2003MY Wheel/Tyre Supplement

JJM 10 02 99/30

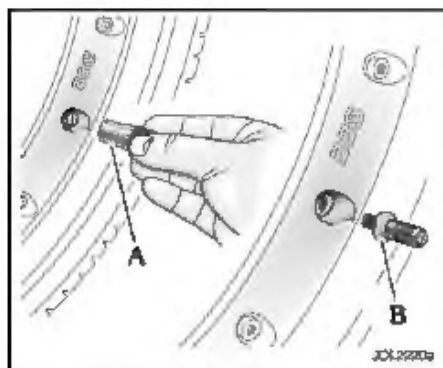
The tool for removing the valve cover has changed (see Section 7 of the Driver's Handbook).

To access the valve, unscrew the slotted valve cover using the special tool (A). Screw in the adaptor (B) and hand-tighten.
